P&Z CASE # SP 2019-040 P&Z DATE 10/29/2019 <sup>P&Z</sup> QC DATE 11/12/2019 APPROVED/DENIED

**Project Number: SP2019-040**  
**Project Name: Ellis Centre Phase 2 Addition**  
**Project Type: SITE PLAN**  
**Applicant Name: HALFF ASSOCIATES**  
**Owner Name: ROCKWALL URBAN INDUSTRIAL, LP**  
**Project Description:**

## City of Rockwall Project Plan Review History

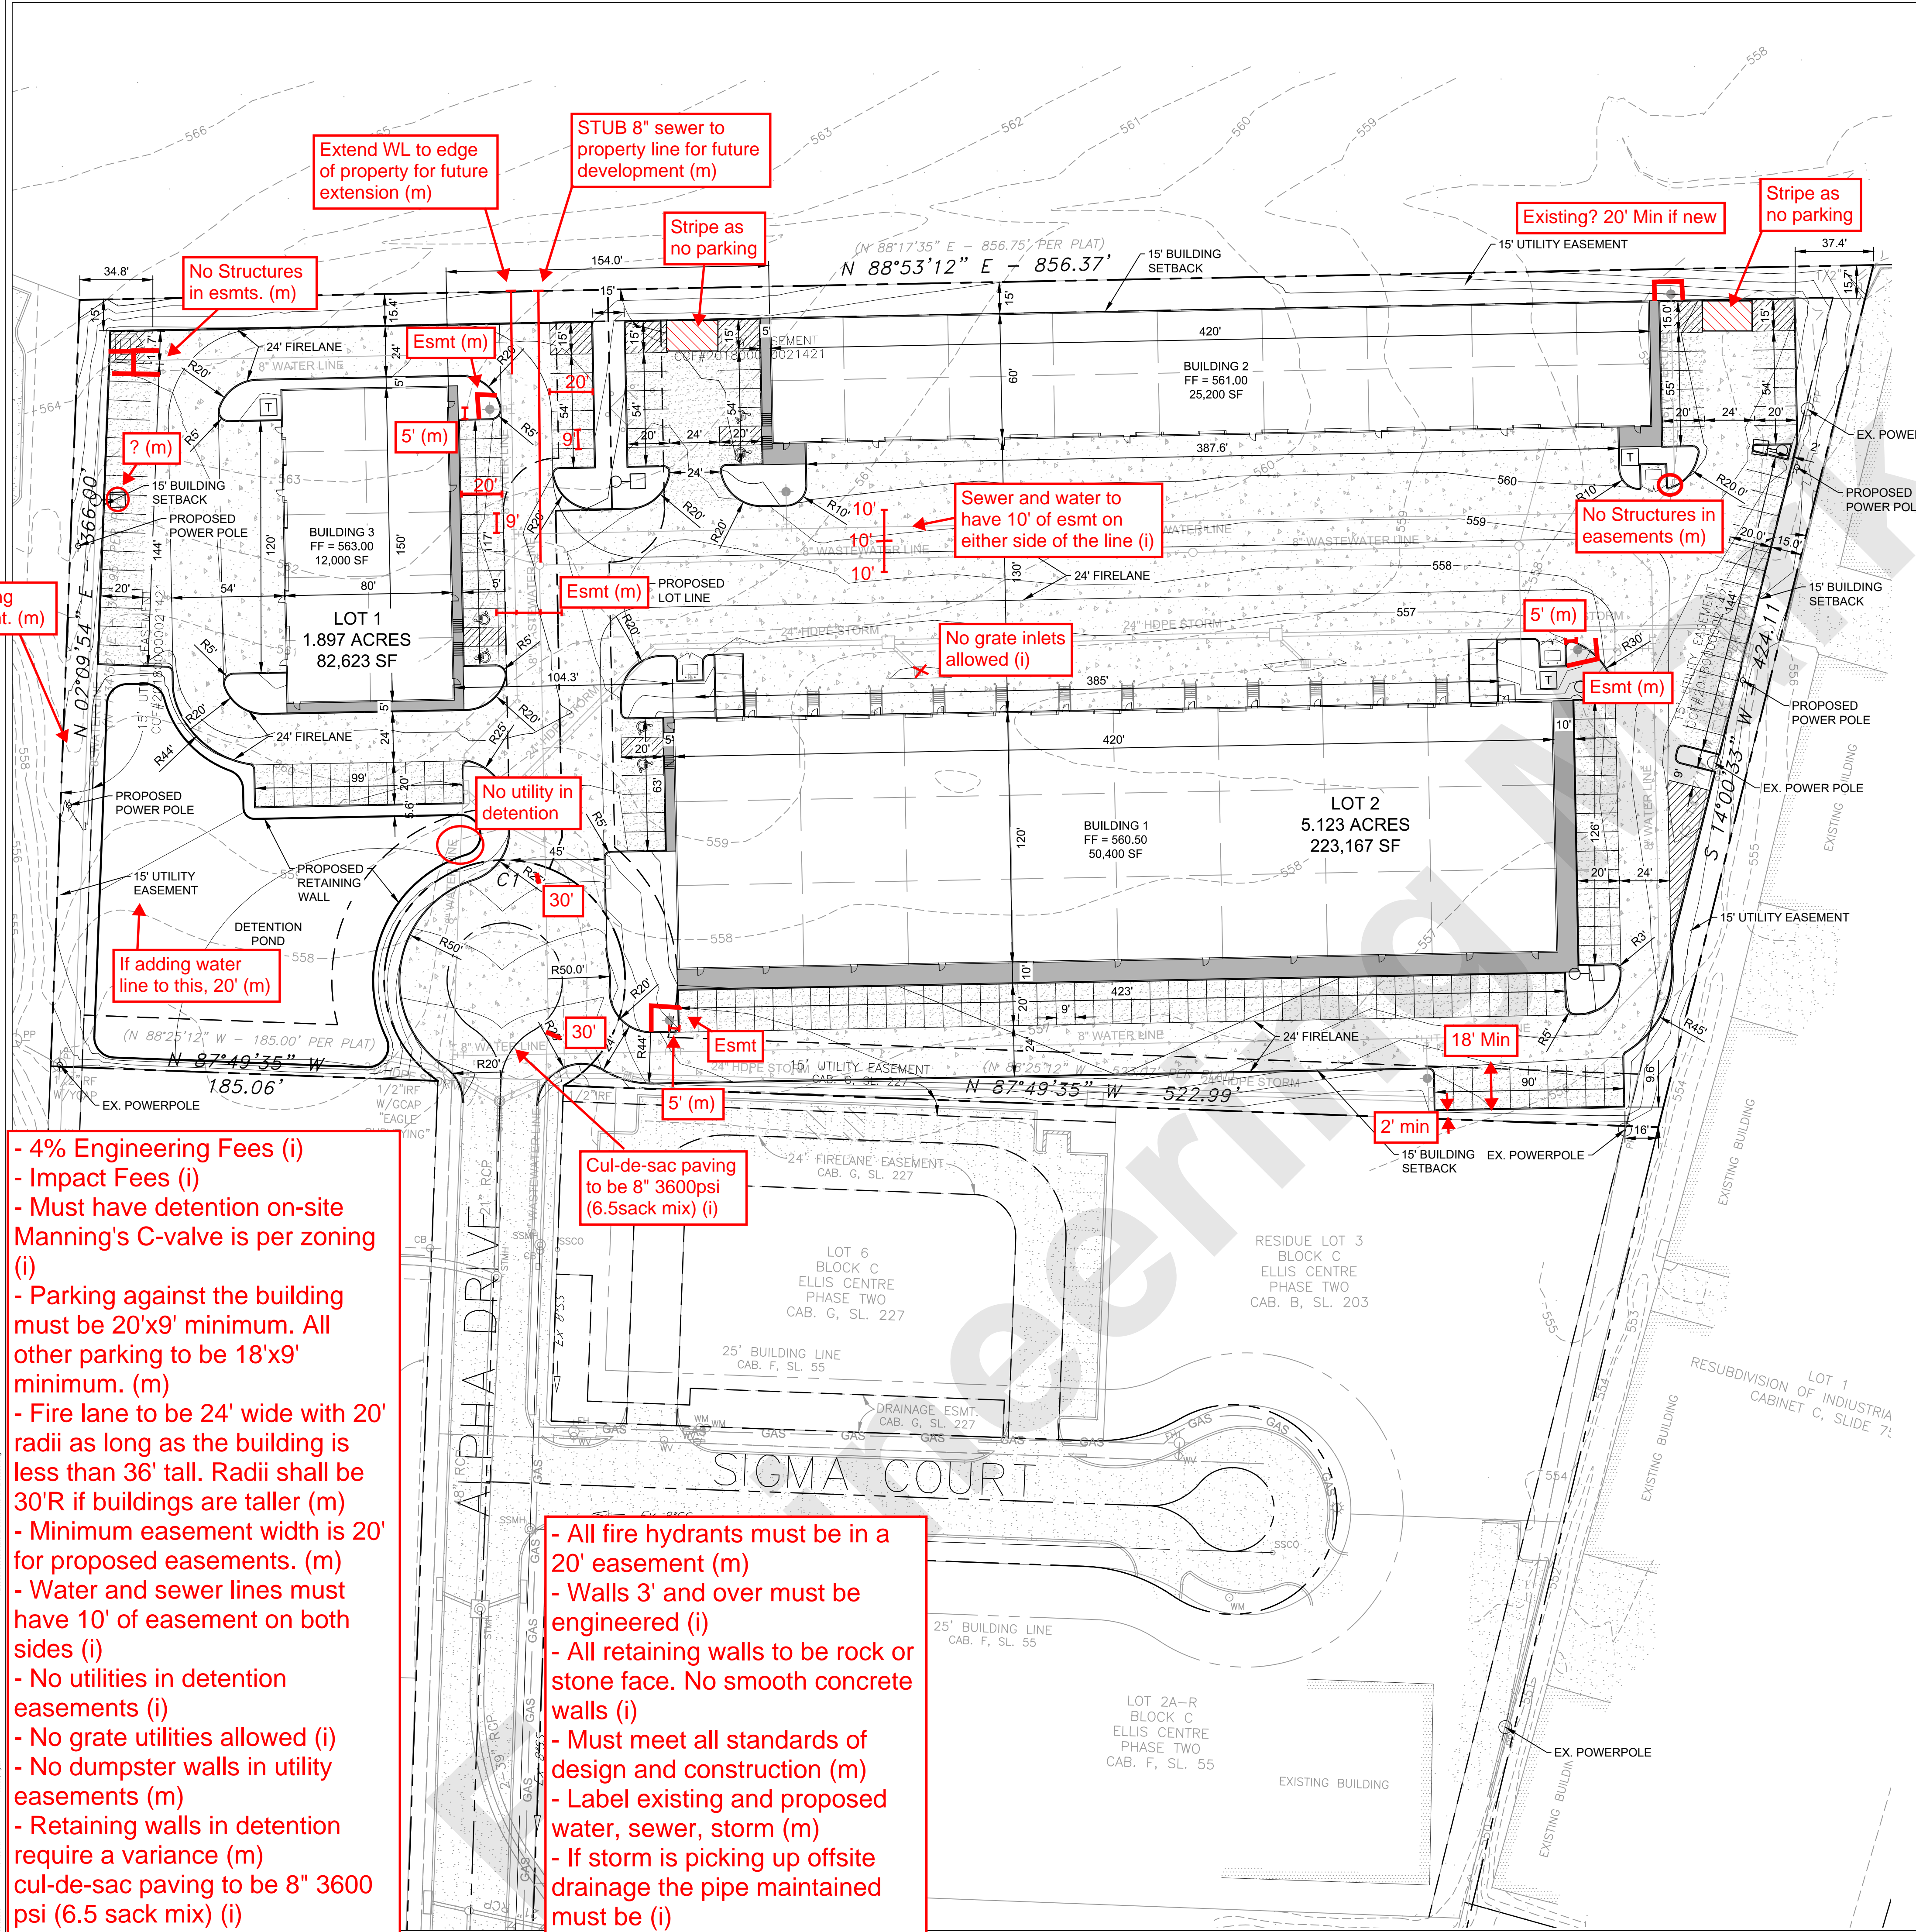
I.5 Please note that the property will require a replat prior to the issuance of a building permit.						
M.6 Site Plan. Please make the following clarifications on the site plan to ensure staff can properly review this project and convey all of the required elements to the City's boards and commissions:

1) Please provide a label for the parking count for each row of spaces in order to determine total parking count						
2) The cross sections of concrete pavement thickness is to be determined by the engineering department during the civil submittal process and is not considered to be approved during this site plan process.

4) Provide a standard signature block with signature space for the Planning and Zoning Chairman and Planning Director.						
5) Is there a front building set back? If so, this is required to be 25-ft. Please adjust accordingly.

6) Provide a label for all drive aisle widths.						
7) Indicate and label all sidewalk widths proposed for this site.						
8) Delineate and label all loading dock parking spaces. Minimum 12-ft wide & 65-ft in length. (Art. VI, Section 6.04)

9) Ground mounted utility equipment and RTUs shall be screened from adjacent public rights-of-way and adjacent property. Provide screening detail for these units. (Art. V, Sec. 1.05.3)

10) Provide screening along the western property boundary from the school district property. (Art. VIII, Sec. 5.02.B Landscape Screening)						
11) Will there be any outside storage of materials, products, etc.?						
M.8 Building Elevations. According to Subsection 5.01.A1, of the General Industrial District Standards, of Article V, District Development Standards, of the UDC, requires a minimum of 20% stone (i.e. natural or synthetic/cultured) on all building façades. In this case, the construction of the addition does not include stone on any façade. This will require an exception from the Planning and Zoning Commission pending a recommendation from the Architectural Review Board(ARB).						
M.9 Building Elevations. According to Subsection 5.01A.1, General Industrial District Standards, of Article V, District Development Standards, of the UDC, each exterior wall of a building's façade shall consist of a minimum of 90% primary materials and ten (10) percent secondary materials. In this case, the construction consists of concrete tilt-up wall. The use of concrete tilt-up walls may be permitted on a case-by-case basis in accordance with the exception requirements outlined in this section of the UDC This will require an exception from the Planning and Zoning Commission pending a recommendation from the Architectural Review Board(ARB).

**PLANTING PLAN**

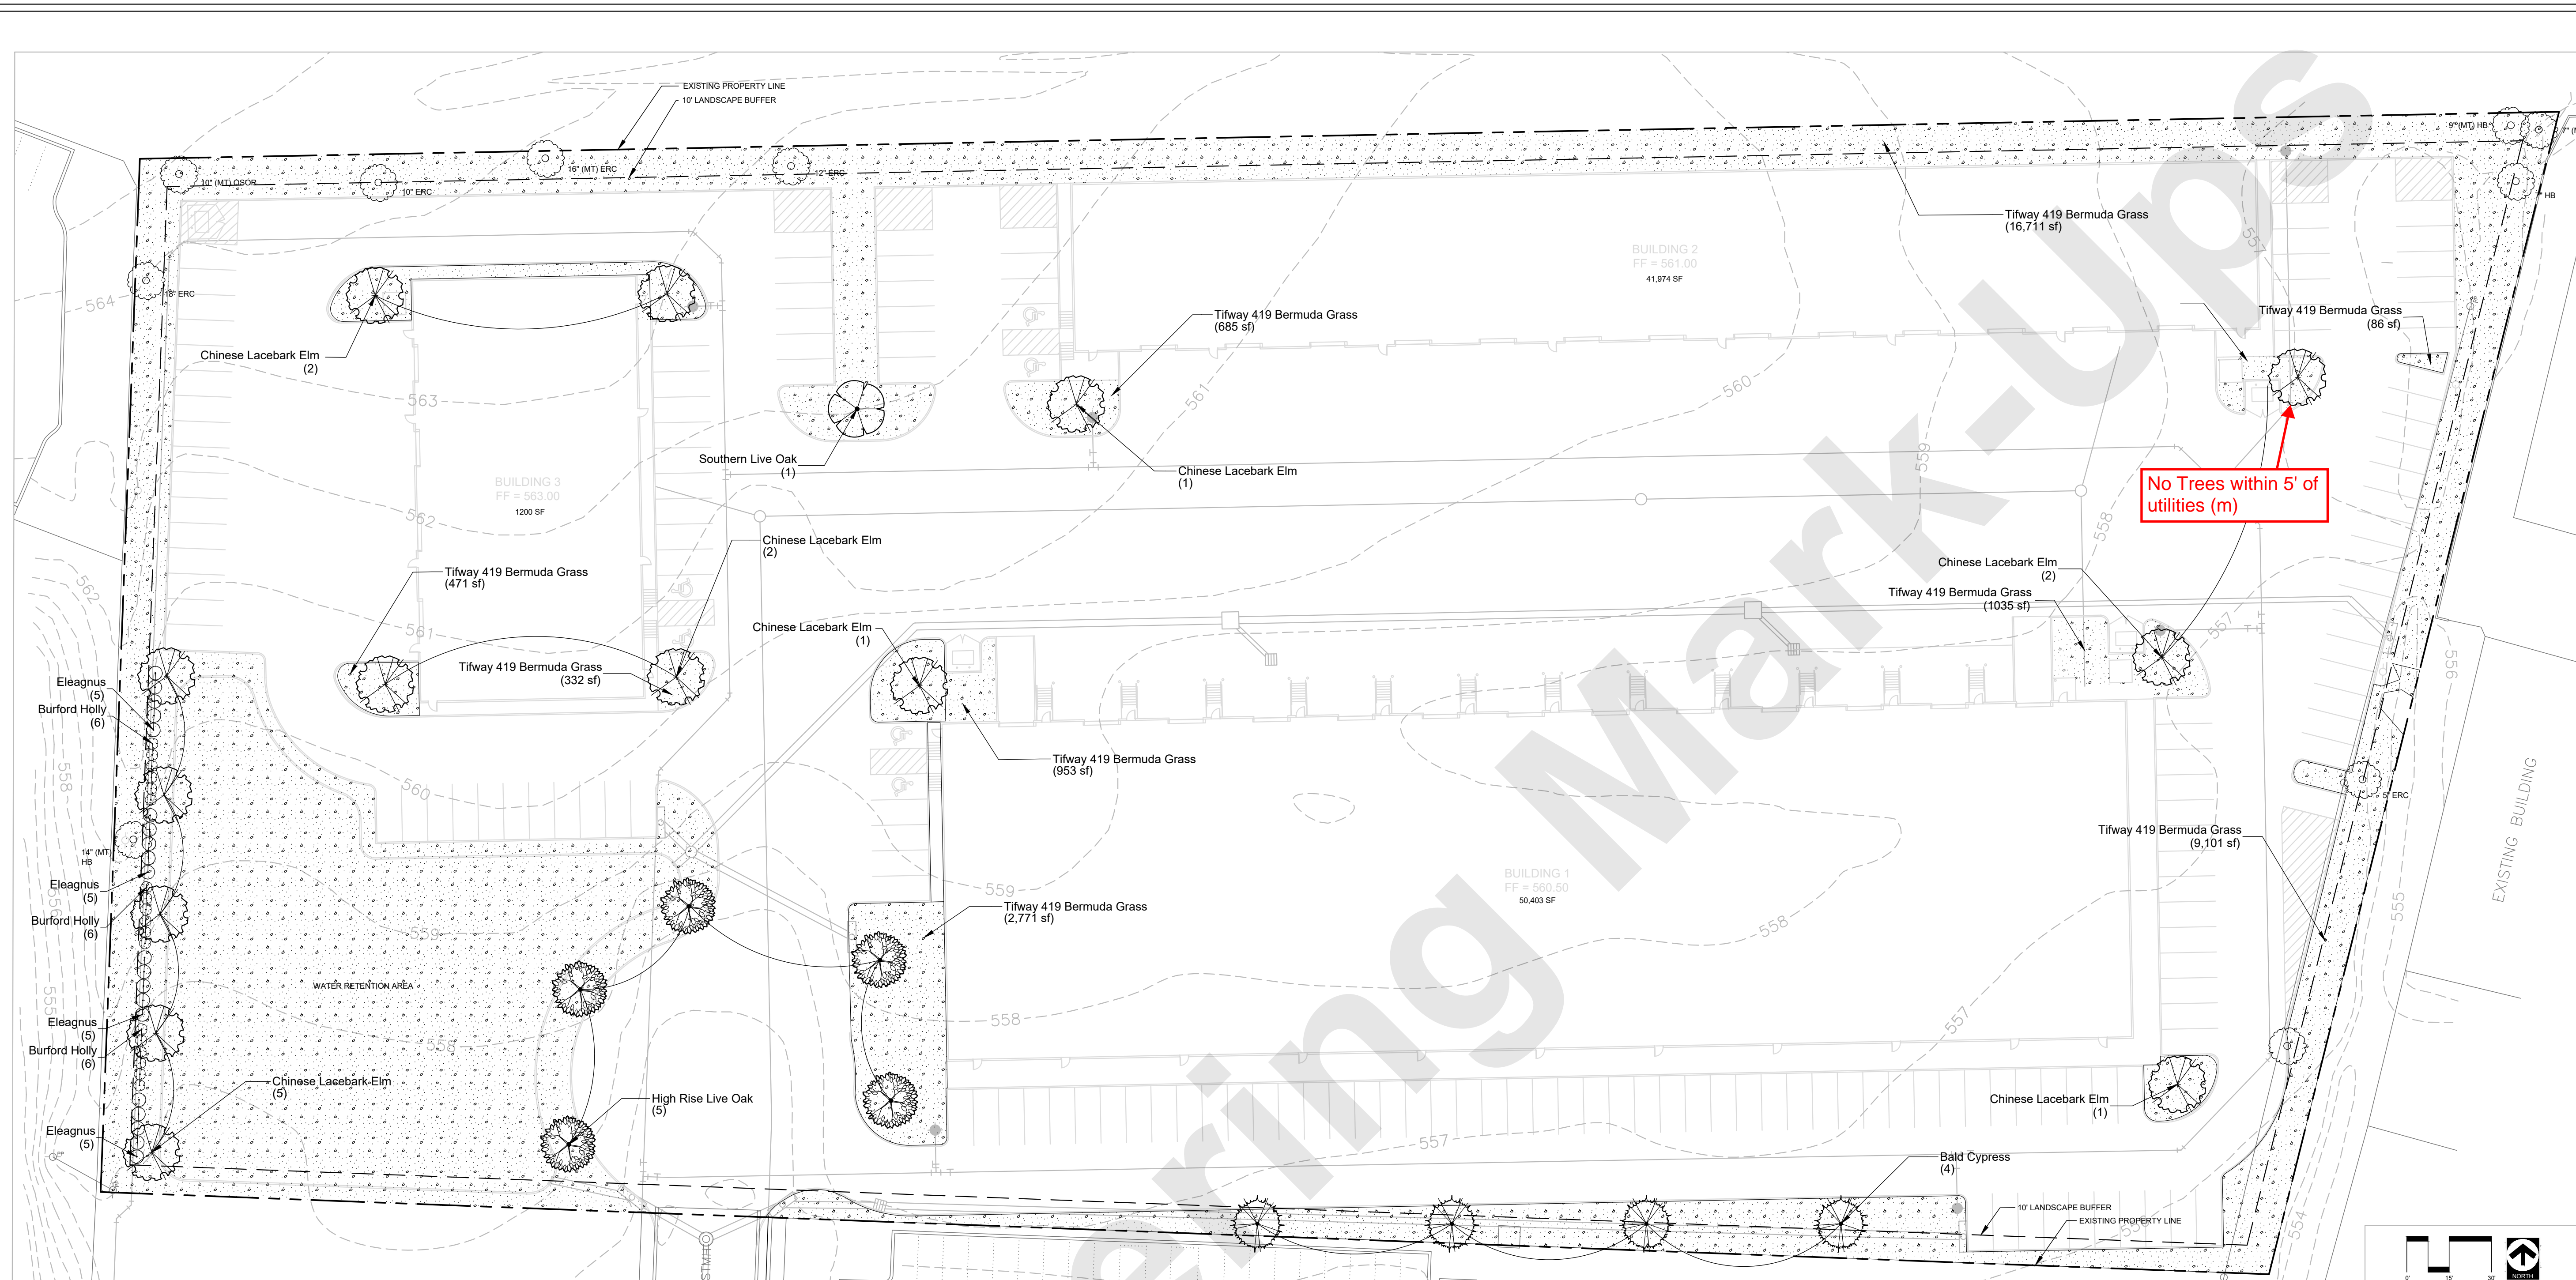
Type of Review / Notes	Contact	Sent	Due	Received	Elapsed Status	Remarks
<p>(10/24/2019 4:26 PM SJ)</p> <p>M - Add note, "No trees within 5' of utilities" to the landscape plan.</p> <p>M - Parking near the building to be 20'x9'. All other parking to be 18'x9'. Standards of Design 2.19</p> <p>M - All fire lane radii to be 20' min. If the building is 36' or taller, the fire lane radius must be 30' min. Standards of Design 2.19</p> <p>M - Driveway radii to be 30' min. Standards of Design 2.19</p> <p>M - No structures in easements. This includes retaining walls and footings, dumpster and screening wall must be out of easements. Standards of Design 6.4.1</p> <p>M - All fire hydrants must have a 20'x20' easement established. Fire hydrants to have 5' of clearance around all sides. Standards of Design 5.3.1</p> <p>M - Must show existing utilities and your planned service connections.</p> <p>M - Minimum easement width is 20' for proposed easements. Standards of Design 5.3.1 and 6.4</p> <p>M - Retaining walls in detention require a variance Standards of Design 3.3.2</p> <p>M - Must stub out the 8" water and 8" sewer to the northern property for future expansion</p> <p>M - Must meet all standards of design and construction.</p> <p>I - 4% Engineering Fees</p> <p>I - Impact Fees</p> <p>I - Must have detention on-site Manning's C-valve is per zoning</p> <p>I - Water and sewer lines must have 10' of easement on both sides</p> <p>I - No utilities in detention easements</p> <p>I - No grate utilities allowed</p> <p>I - Cul-de-sac paving to be 8" 3600 psi (6.5 sack mix)</p> <p>I - No sand is allowed under paving.</p> <p>I - Walls 3' and over must be engineered</p> <p>I - All retaining walls to be rock or stone face No smooth concrete walls</p> <p>I - If storm is picking up offsite drainage the pipe maintained must be</p> <p>I - Where you show the 15'x64' turnaround, you must stripe the entire area as no parking.</p>
